PARTS & SERVICE NEWS

REF NO. AA04072

SUBJECT: IMPROVED ENGINE CYLINDER HEAD

PURPOSE: To introduce a modification procedure to improve the cylinder head on the engine.

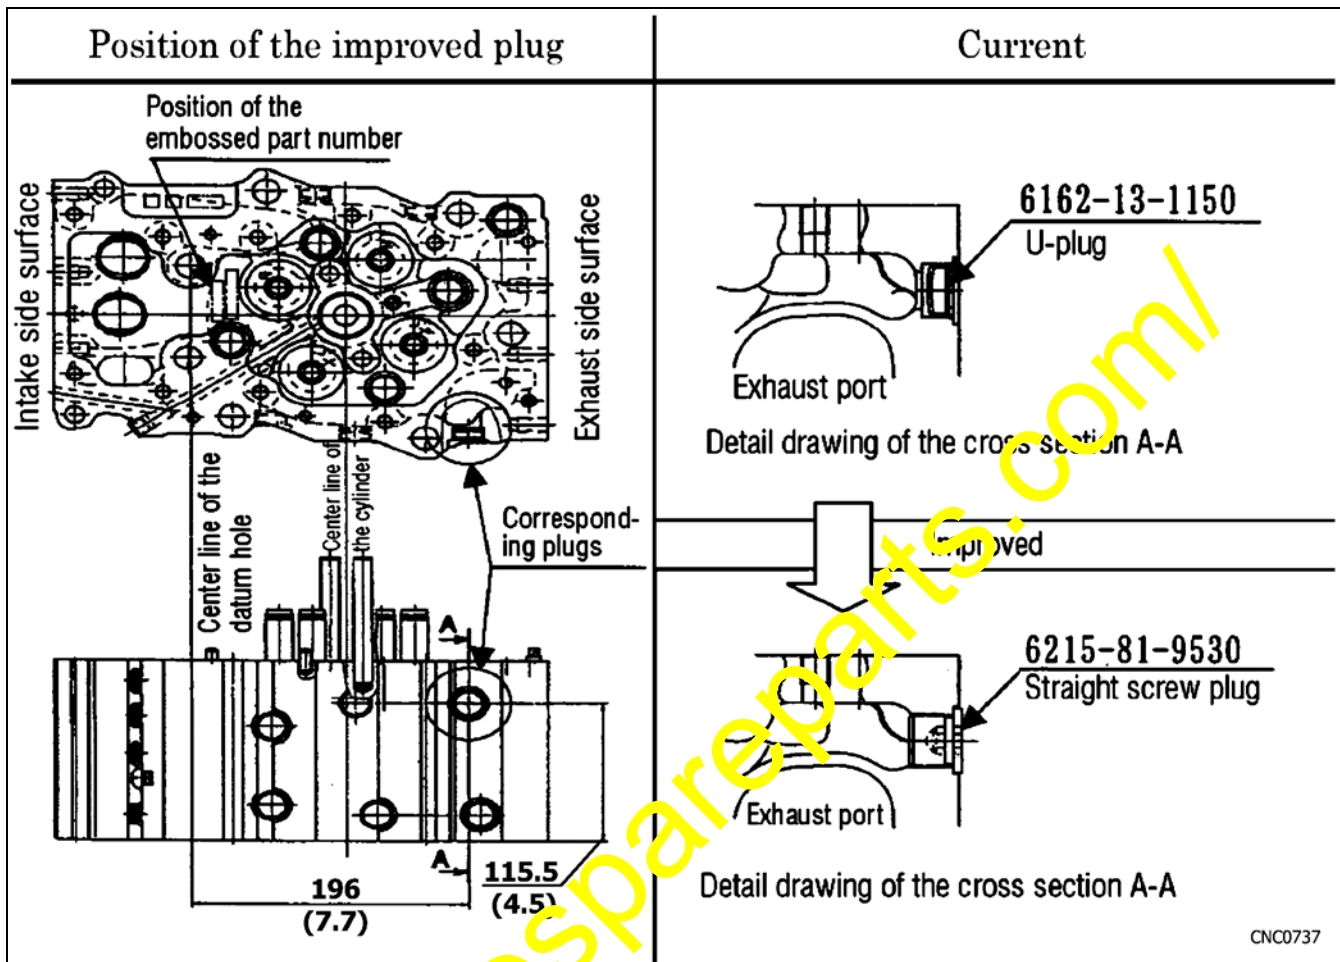
★ To improve the security against water leakage from the U-plug portion of the cylinder head, the plug shape has been modified.

The U-plug (6162-13-1150) has been changed to the straight screw plug (the following part).

Carrying out this modification by replacing the cylinder head assembly: 6215-81-9530 (M22 X 1.5)

Carrying out this modification by reworking of the cylinder head: 6240-81-9560 (M24 X 1.5)

★ Modification Method (A)

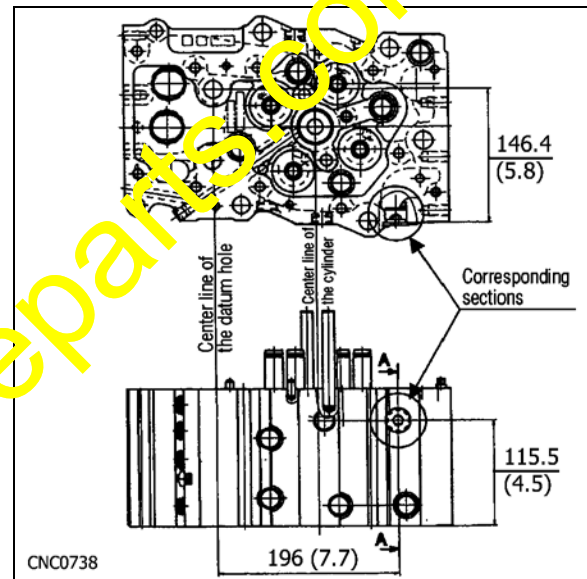
1. Remove the cylinder head as per the Shop Manual for the Engine.
2. Remove the valve, valve spring, etc. from the cylinder head assembly.
3. Replace the cylinder head with the improved one.
 - a. Replace the valve and stem seal with new parts.
 - b. Cylinder head assembly (without valve): 6240-11-1101 / 6240-11-1102
4. Reinstall the removed parts as per in the Shop Manual for the Engine. Replace the consumable parts like the gaskets, seals, etc. with new parts.

★ Modification Method (B-1)

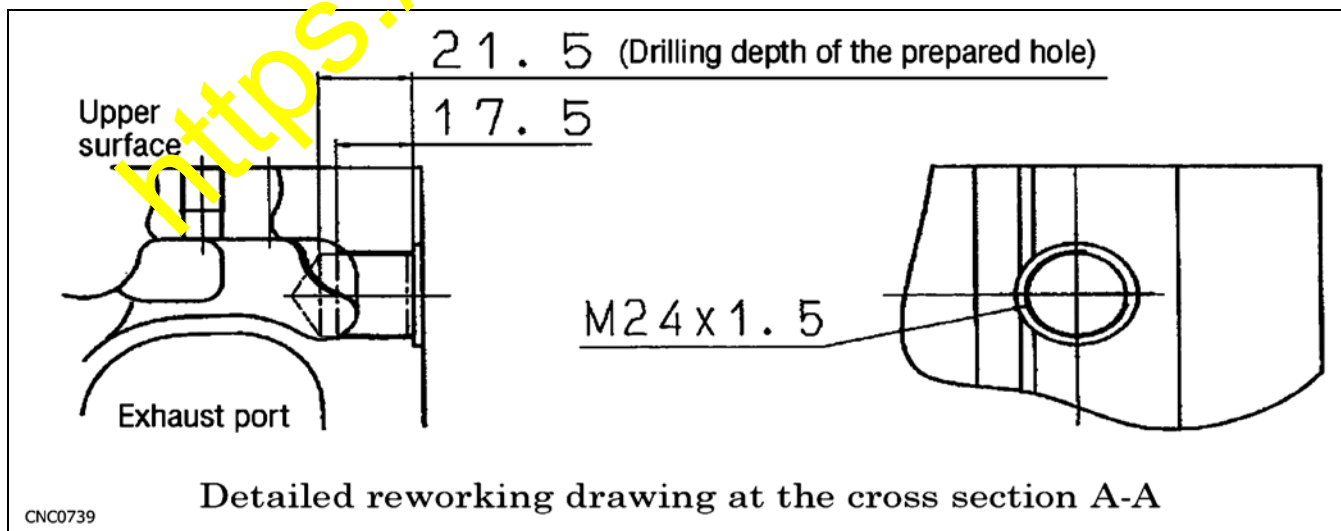
1. Remove the valve, valve spring, and related parts from the cylinder head assembly as per in the Shop Manual for the Engine.
2. Remove the U-plug from the cylinder head.

When carrying out this modification by reworking, remove all the blind plugs used on the cylinder head and wash the inside after finishing the reworking in order to secure the cleanliness inside the cylinder head.

3. Rework to make the "M24 X 1.5" tapped hole as per illustration. When drilling the prepared hole, be fully careful not to damage the wall surface of the exhaust port.
